Contract #: 04-0120F4
 Cty: SF/ALA Rte: 80 PM: 13.2/13.9
 File #: 69.25B

QUALITY ASSURANCE -- NON-CONFORMANCE REPORT

Report No: NCR-000776

Subject: Add Weld joint for OBG floorbeam stiffener X3630B

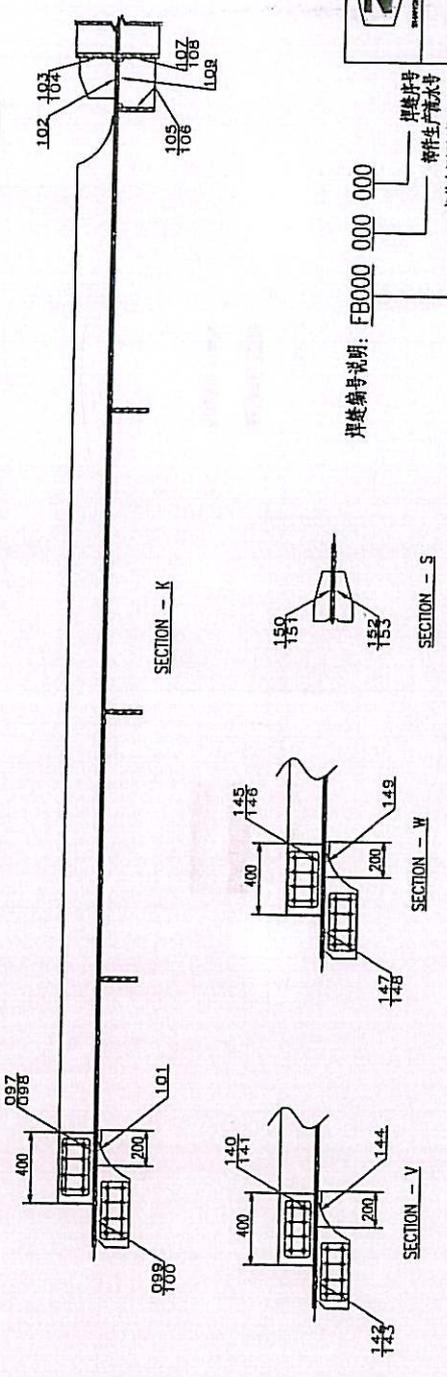
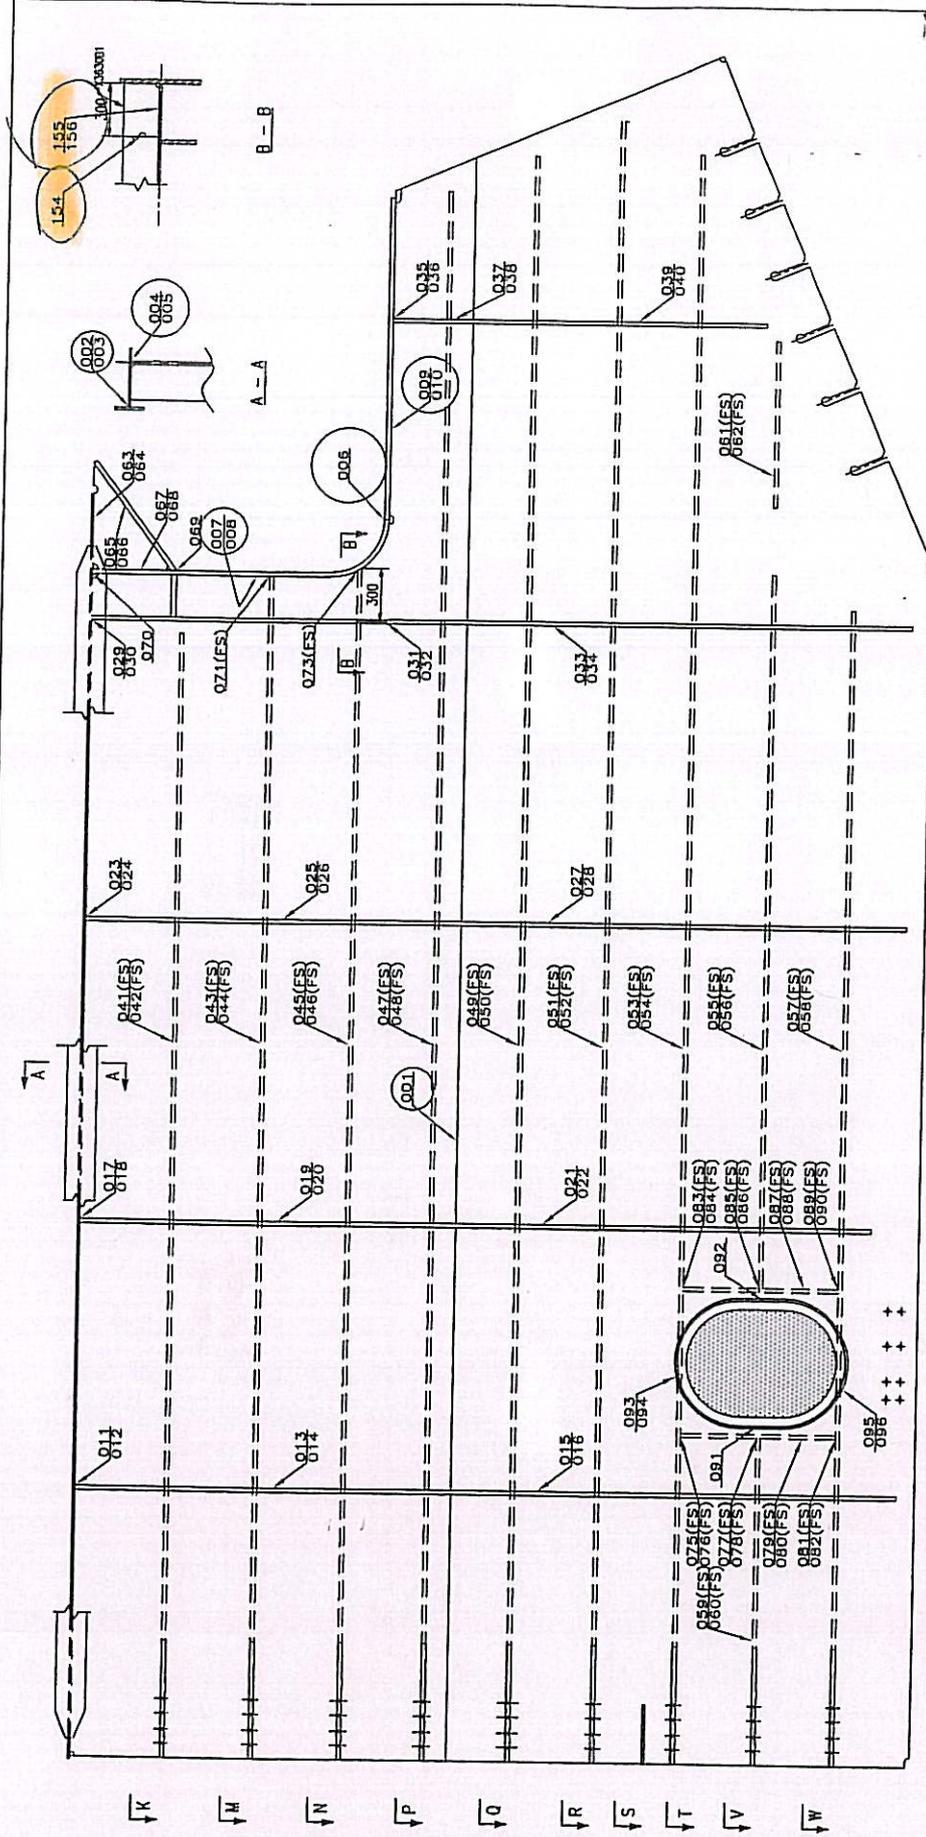
Please find attached shop drawings X3630 & FB3138, it is confirmed that the dimension for stiffener X3630B is incorrect, it is short for 30mm if connect to the flange plate.

To facilitate fabrication ZPMC propose to cut the X3630B with 270mm and then add weld joint for the X3630B and a new stiffener with 300mm length.

Please confirm if it is acceptable.

The proposal is acceptable with the following requirements (see attached photo with comments):

- perform 100% UT on the X3630B CJP Splice weld to the added 300mm PL;
- perform 100% MT on both fillet welds connecting the added 300mm plate to the floorbeam + 75mm past the fillet weld intersection with the CJP;
- add a 25mm cope hole by backgouging where the CJP weld intersects with the fillet welds;
- and, revise and re-submit the weld map to include the new weld and its ID.
